Piper Aircraft Corporation

SUBJECT: Gascolator Bowl Drain Valve

MODELS AFFECTED: PA-24 and PA-24 "250" Comanche Aircraft - Serial Numbers 24-2500 to 24-2700 inclusive

SERVICE BULLETIN #208

FUEL STRAINER DRAIN VALVE

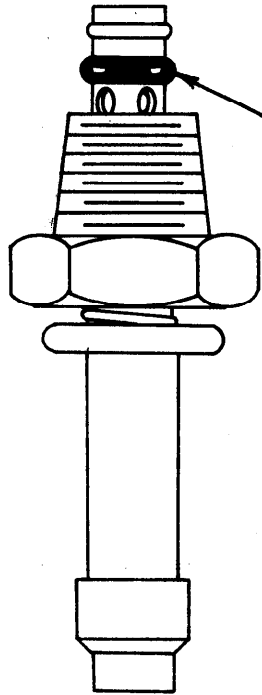
The failures have occurred as a result of machining the valve. The longitudinal hole drilled through the stem has penetrated the stem too deeply; thus weakening the stem adjacent to the "O" ring. It is requested that the valves installed in the aircraft indicated by the above serial numbers be inspected in the following manner:

1. Remove the belly access panel at the drain valve.
2. Look into the longitudinal hole in the valve stem and note if the cross-drill marks resulting from the cross-drilling of the stem adjacent to the "O" ring are visible.

Refer to the sketch on the reverse side of this Bulletin.

If the cross-drilling marks are observed, the valve may be considered satisfactory and no further action is required.

If the cross-drilling marks are not observed, the valve must be replaced.

All existing valves, part number 22179-00, now in distributor-dealer stocks must be inspected and replaced if incorrectly drilled.
